Subject: Class II permissive change Request
FCC ID: 2AZ9X-HBMFX

Granted on: 07/29/2021

Comparison between the old and new photos and circle the differences
Picture

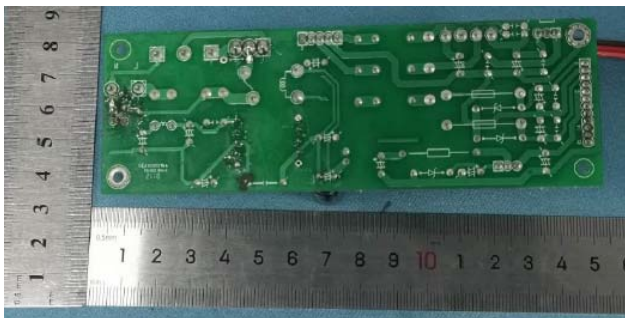
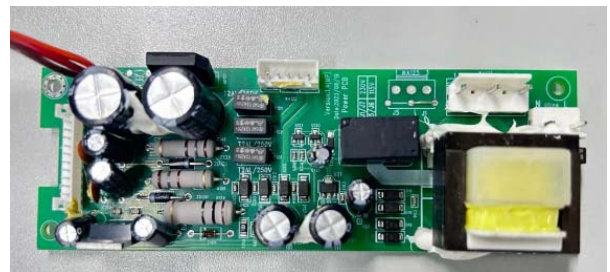
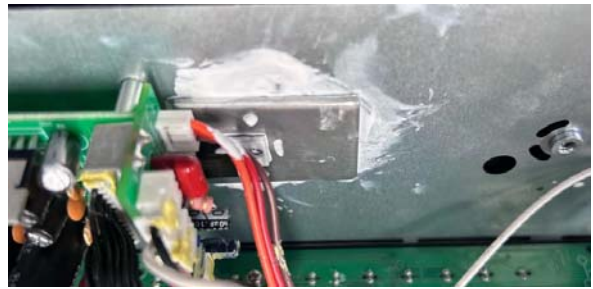
1. The small power supply board (auxiliary power supply) is changed to a linear transformer, and the main power transformer is unchanged;
2. The three glass tube fuses on the small power supply board are changed to box fuses;
3. Changes in the installation mode of the power amplifier IC (will affect the overall temperature rise).
